USSN 09/833,711

Amendments to Drawings

FIG. 5a

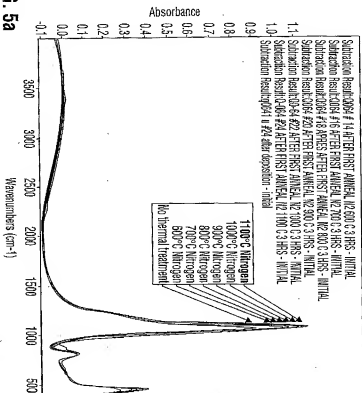
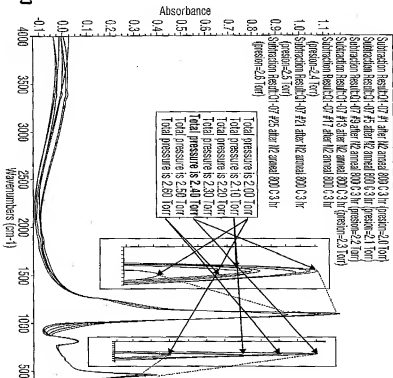
Permission is respectfully requested to amend Figures 5a, 5b, 6a, 7a, 8a, 9a, and 10a of the drawings as shown in the attached copy. The legends have been redrawn to make them not blurry.
